Monticello Nuclear Generating Plant
2807 W County Road 75
Monticello, MN 55362

L-MT-15-032
10 CFR 50.90

Monticello Nuclear Generating Plant
Docket 50-263
Renewed Facility Operating License No. DPR-22

License Amendment Request to Revise Technical Specification Surveillance
Requirement 3.5.1.3.b to Correct the Alternate Nitrogen System Pressure

MONTICELLO NUCLEAR GENERATING PLANT
FIGURE 1 ALTERNATE NITROGEN SYSTEM

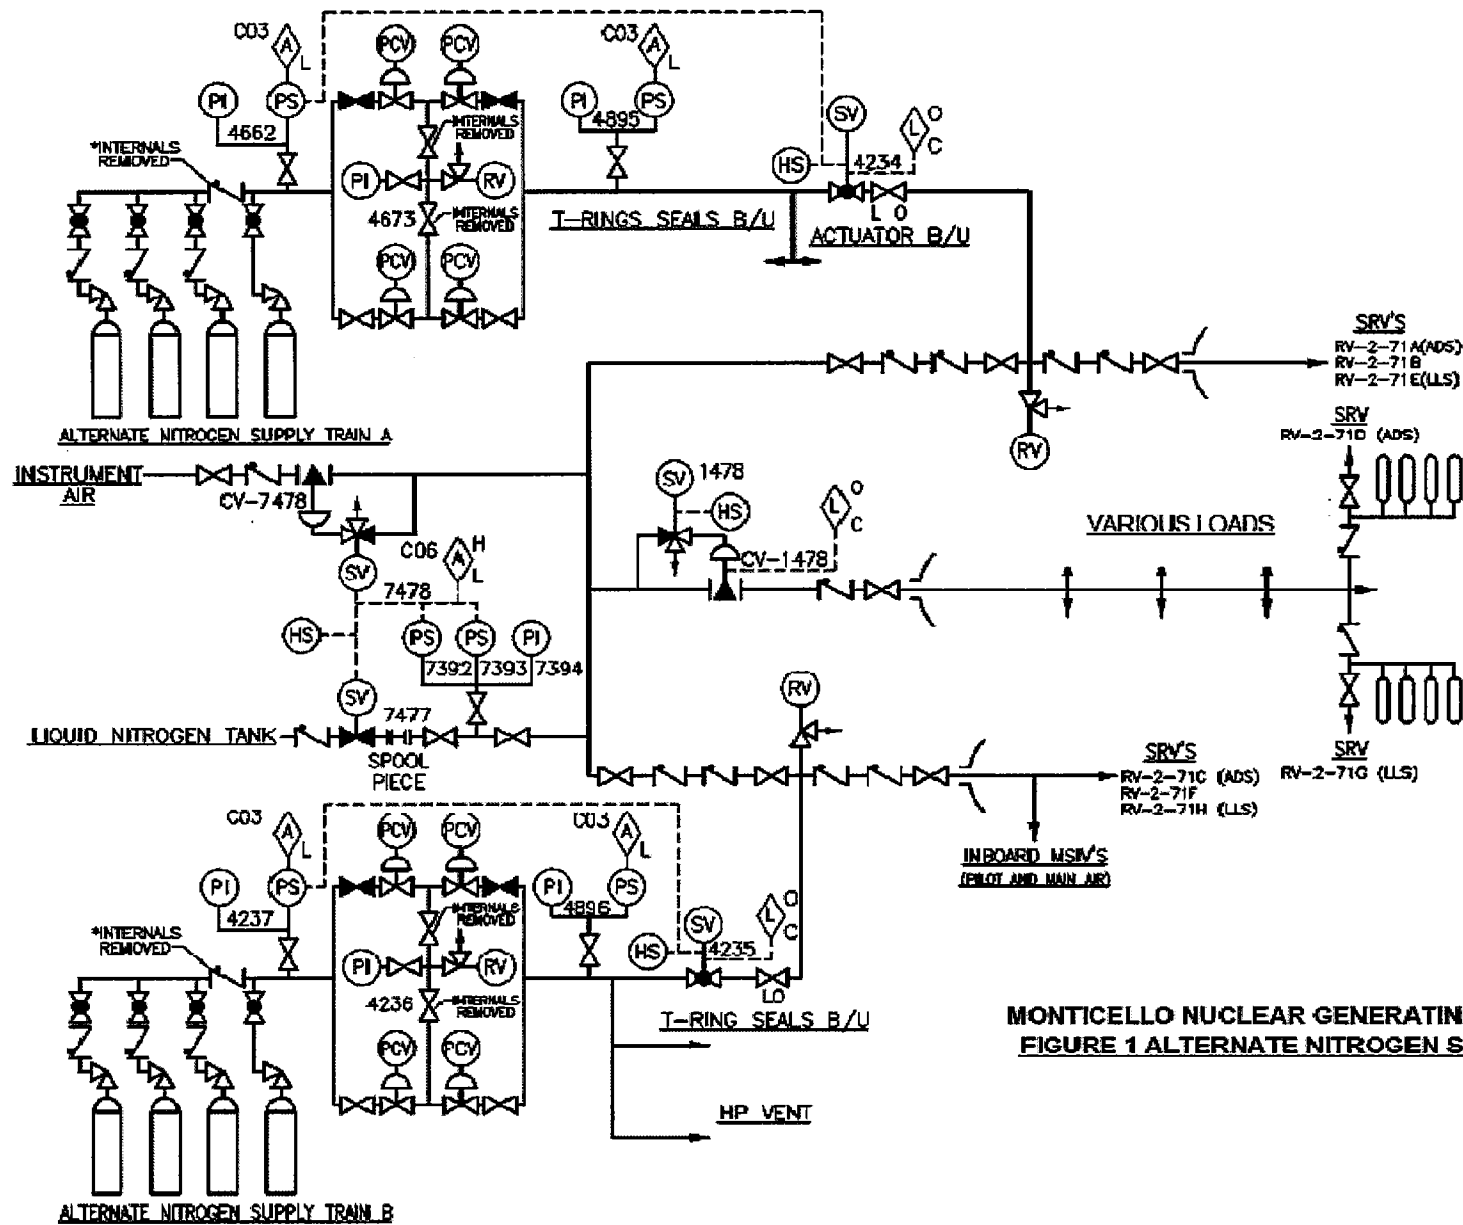
System provides backup pneumatic supply to the T-ring seals of the outboard Primary Containment and Atmospheric Control System purge and vent valves, the actuators of the inboard MSIVs, and SRVs C, F, and H. Train B also provides the sole pneumatic supply to the Primary Containment Hard Pipe Vent System isolation valves and rupture disc. In each Alternate Nitrogen System train, one SRV is assigned to perform the ADS function, a different SRV performs the low-low set (LLS) function, and another SRV is available to perform alternate shutdown and manual depressurization functions. One ADS SRV and one LLS SRV have an associated accumulator bank that provides pneumatic pressure for valve actuation. Figure 1 in Attachment 1 shows the basic Alternate Nitrogen System configuration.
